Package Title: Construction of Tunnelling Works including Testing and Commissioning for Double Line High Speed Railway using Tunnel Boring Machine (TBM) and New Austrian Tunnelling Method (NATM) between Mumbai Underground Station at Bandra-Kurla Complex (MAHSR Km. 0.773) and Shilphata (MAHSR Km. 21.150) in the State of Maharashtra for the Project for Construction of Mumbai-Ahmedabad High Speed Rail.

Package No: MAHSR-C-2

Response to Bid Queries-3

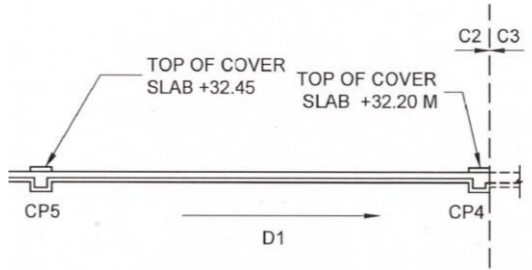
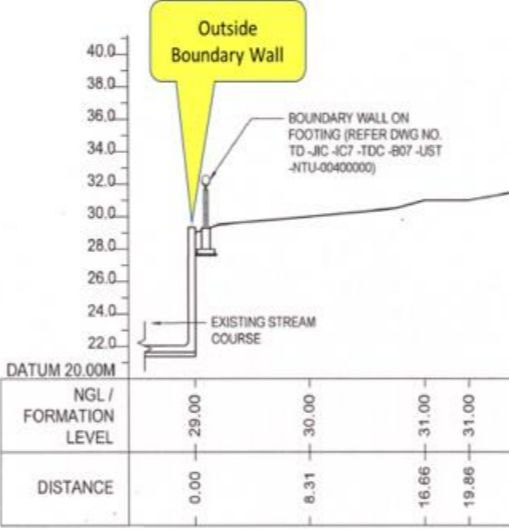
5.	Part 2 Section VI-3 Drawings from Addendum #2 C. SHAFT-2	Pages 114 & 115 of 119	Missing drawing & confirmation of drawing	1. <u>Drawing 16290000 / SHAFT-2 - PERMANENT REINSTATEMENT AND ASSOCIATED WORKS (RETAINING WALL) (1)</u> Drawing is listed in "NEW LIST OF DRAWINGS as per Attachment of Addendum No. 2 but is not found in the actual set of pdf drawings. Please provide us the missing drawing	1. Refer Addendum No. 4 Item No. 3. 2. Refer Addendum No. 4 Item No. 2.

No.	Part & Section Reference	Page No. / Clause No.	Provisions as Per-Bidding Documents	Bidder Query	Employer's Reply
	DRAWINGS TD-JIC-IC1- TDC-B01-UST- NTU- 16290000 (NEW) & 16300000 (NEW)			<p>2. <u>Drawing 16300000 / SHAFT-2 - PERMANENT REINSTATEMENT AND ASSOCIATED WORKS (RETAINING WALL) (2)</u></p> <p>There are two versions in the actual set of pdf drawings; on pages 114 and 115 of 119 as indicated respectively below.</p> <p>Please confirm the correct version.</p> <div style="display: flex; justify-content: space-around;"> <div data-bbox="1320 485 1762 1291"> <p>REFERENCE DRAWINGS</p> <ol style="list-style-type: none"> SHAFT 2 - RETAINING WALL (1) TD-JIC-IC1-TDC-B01-UST-NTU-16290000 SHAFT 2 - ROAD (1) TD-JIC-IC1-TDC-B01-UST-NTU-16300000 DETAIL OF BOUNDARY WALL ON RETAINING WALL TD-JIC-IC7-TDC-B07-UST-NTU-00420000 DETAIL OF DRAIN (2) TD-JIC-IC7-TDC-B07-UST-NTU-00440000 DETAIL OF GATE (G1) TD-JIC-IC7-TDC-B07-UST-NTU-00490000 <p>GENERAL NOTES</p> <ol style="list-style-type: none"> ALL DIMENSIONS ON DRAWINGS ARE SHOWN IN MM. DRAWINGS NOT TO BE SCALED, ONLY WRITTEN DIMENSIONS TO BE FOLLOWED. ALLOWABLE SBC SHALL BE 16TSQM OR MORE, THE SAME SHALL BE CONFIRMED BY PLATE LOAD TEST PRIOR TO CONSTRUCTION. GRADE OF CONCRETE SHALL BE M-35 AS PER IS:456. GRADE OF REINFORCEMENT SHALL BE F4500 AS PER IS:1786. CLEAR COVER TO MAIN REINFORCEMENT SHALL BE AS FOLLOWS:- a) RETAINING WALL = 40 mm SURCHARGE LOAD FOR ALL WALL = 25KN/M² BACKFILLING WITH SUITABLE MATERIAL IN LAYERS NOT EXCEEDING 300MM IN THICKNESS TO ACHIEVE 90% COMPACTION. <p>Adopted by: NHSRCL</p> <p>Title: SHAFT 2 - PERMANENT REINSTATEMENT AND ASSOCIATED WORKS (RETAINING WALL) (2)</p> <p>Scale: 1:25 @ A1</p> <p>Drawing No. TD-JIC-IC1-TDC-B01-UST-NTU-16300000</p> </div> <div data-bbox="1804 485 2237 1291"> <p>REFERENCE DRAWINGS</p> <ol style="list-style-type: none"> SHAFT 2 - RETAINING WALL (1) TD-JIC-IC1-TDC-B01-UST-NTU-16290000 SHAFT 2 - ROAD (1) TD-JIC-IC1-TDC-B01-UST-NTU-16300000 DETAIL OF BOUNDARY WALL ON RETAINING WALL TD-JIC-IC7-TDC-B07-UST-NTU-00420000 DETAIL OF DRAIN (2) TD-JIC-IC7-TDC-B07-UST-NTU-00440000 DETAIL OF GATE (G1) TD-JIC-IC7-TDC-B07-UST-NTU-00490000 <p>GENERAL NOTES</p> <ol style="list-style-type: none"> ALL DIMENSIONS ON DRAWINGS ARE SHOWN IN MM. DRAWINGS NOT TO BE SCALED, ONLY WRITTEN DIMENSIONS TO BE FOLLOWED. GRADE OF CONCRETE SHALL BE M-35 AS PER IS:456. HOT ROLLED DEFORMED BARS WITH CHARACTERISTIC STRENGTH F_{yk} = 500D (IS 1786) SHALL BE USED FOR REINFORCEMENT. CLEAR COVER TO MAIN REINFORCEMENT SHALL BE AS FOLLOWS:- a) RETAINING WALL = 40 mm SURCHARGE LOAD FOR ALL WALL = 25KN/M² BACKFILLING WITH SUITABLE MATERIAL IN LAYERS NOT EXCEEDING 300MM IN THICKNESS TO ACHIEVE 90% COMPACTION. ALL STRUCTURES HAVE BEEN DESIGNED FOR A SAFE BEARING CAPACITY OF 16TSQM FOR THE SOIL. <p>Adopted by: NHSRCL</p> <p>Title: SHAFT 2 - PERMANENT REINSTATEMENT AND ASSOCIATED WORKS (RETAINING WALL) (2)</p> <p>Scale: 1:25 @ A1</p> <p>Drawing No. TD-JIC-IC1-TDC-B01-UST-NTU-16300000</p> </div> </div>

<table><tr> <td data-bbox="1320 195 1765 241">5. Handhole & cable pit covers shall be scope of E1 Contractor.</td> <td data-bbox="1765 195 2240 241">6. Handhole covers shall be in scope of E1 Contractor and cable pit covers shall be in scope of C2 Contractor.</td> </tr><tr> <td data-bbox="1320 441 1765 472">Drawing No. TD-JIC-IC1-TDC-B01-UST-NTU-10490001</td> <td data-bbox="1765 441 2240 472">Drawing No. TD-JIC-IC1-TDC-B01-UST-NTU-10500001</td> </tr></table>

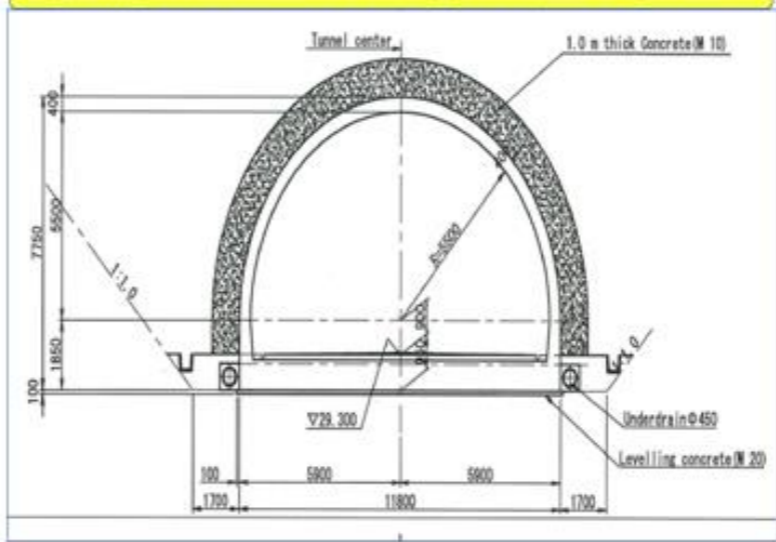
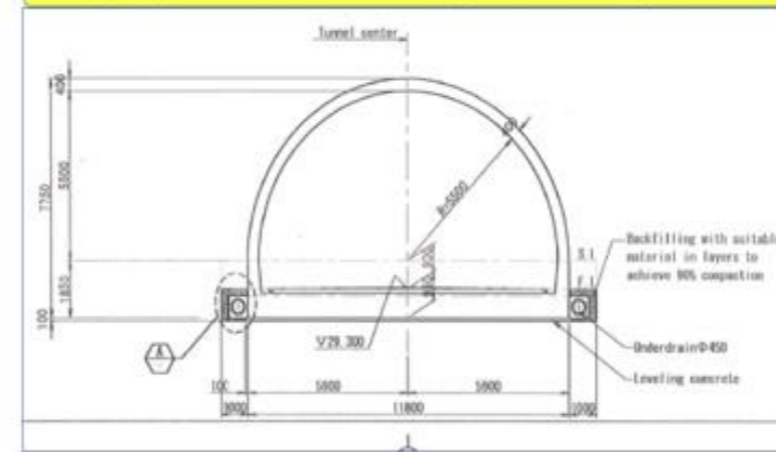
6.	Part 2 Section V1-3 Drawings from Addendum #2 B-TBM DRAWINGS TD-JIC-IC1- TDC-B01-UST- NTU- 10490001 (Revised) ~	Pages 27 ~ 31 of 164	Discrepancy between drawings Note.	<p>There is a discrepancy between Note 5 of <u>Drawing No. 10490001 / TBM – CENTER DRAINAGE PIPE DETAIL</u> and <u>Note 6 of Drawings No. from 10500001 to 10530001 / TBM – GENERAL ARRANGEMENT OF EQUIPMENT ROOM</u> regarding the scope of work of E1 and C2 contractor.</p> <p>(Refer to below sketch)</p> <p>Please clarify the contractor for the following scope of works.</p> <ol style="list-style-type: none"> Handhole at all equipment room locations Handhole cover at all equipment room locations Cable pit inside all equipment rooms Cable pit cover inside all equipment rooms 	Refer Addendum No. 4 Item No. 2. Refer Sub-Division 01020 of the General Specifications, Section VI-1, Part 2 for scope of work.

5. Handhole & cable pit covers shall be scope of E1 Contractor.	6. Handhole covers shall be in scope of E1 Contractor and cable pit covers shall be in scope of C2 Contractor.	Adopted by: NHSRCL	Adopted by: NHSRCL	Title CENTER DRAINAGE PIPE DETAIL	Title GENERAL ARRANGEMENT OF EQUIPMENT ROOM (1) (TYPE - A)	Scale S-1:30, 1:60 @A1	Scale S-1:60 @A1	Drawing No. TD-JIC-IC1-TDC-B01-UST-NTU-10490001	Drawing No. TD-JIC-IC1-TDC-B01-UST-NTU-10500001	
5. Handhole & cable pit covers shall be scope of E1 Contractor.	6. Handhole covers shall be in scope of E1 Contractor and cable pit covers shall be in scope of C2 Contractor.														
Adopted by: NHSRCL	Adopted by: NHSRCL														
Title CENTER DRAINAGE PIPE DETAIL	Title GENERAL ARRANGEMENT OF EQUIPMENT ROOM (1) (TYPE - A)														
Scale S-1:30, 1:60 @A1	Scale S-1:60 @A1														
Drawing No. TD-JIC-IC1-TDC-B01-UST-NTU-10490001	Drawing No. TD-JIC-IC1-TDC-B01-UST-NTU-10500001														
7.	Part 2 Section V1-3 Drawings from Addendum #2 A. GENERAL DRAWINGS TD-JIC-IC1-TDC-B01-UST-NTU-00170001 (NEW) and D. SHAFT-3 DRAWINGS TD-JIC-IC1-TDC-B01-UST-NTU-17380001 (REVISED)	Page 4 of 8 And Page 25 of 105	Missing information on the drawing and missing drawing.	<ol style="list-style-type: none"> <u>Drawing 00170001 / WORK AREA ACCESS PLAN SHAFT-3</u> No indications of location of "POINT ID" on the drawing as stipulated in the table of "ACCESS AREA COORDINATES". Please provide us the missing information. <u>Drawing 17380001 / SHAFT-3 - PERMANENT REINSTATEMENT AND ASSOCIATED WORKS (GENERAL ARRANGEMENT DRAWING)</u> "REFERENCE DRAWINGS" stipulate "1. WORKS AREA ACCESS PLAN SHAFT-3" TD-JIC-IC1-B01-UST-NTU-00170000". We consider that drawing 00170000 (from the original tender documents) has been superseded by 00170001 (Revised from Addendum #2). Please confirm our understanding and revise the above reference to be 00170001 in 17380001. <div data-bbox="1525 1306 2059 1759" data-label="Image"> </div>	Refer Addendum No. 4 Item No. 2.
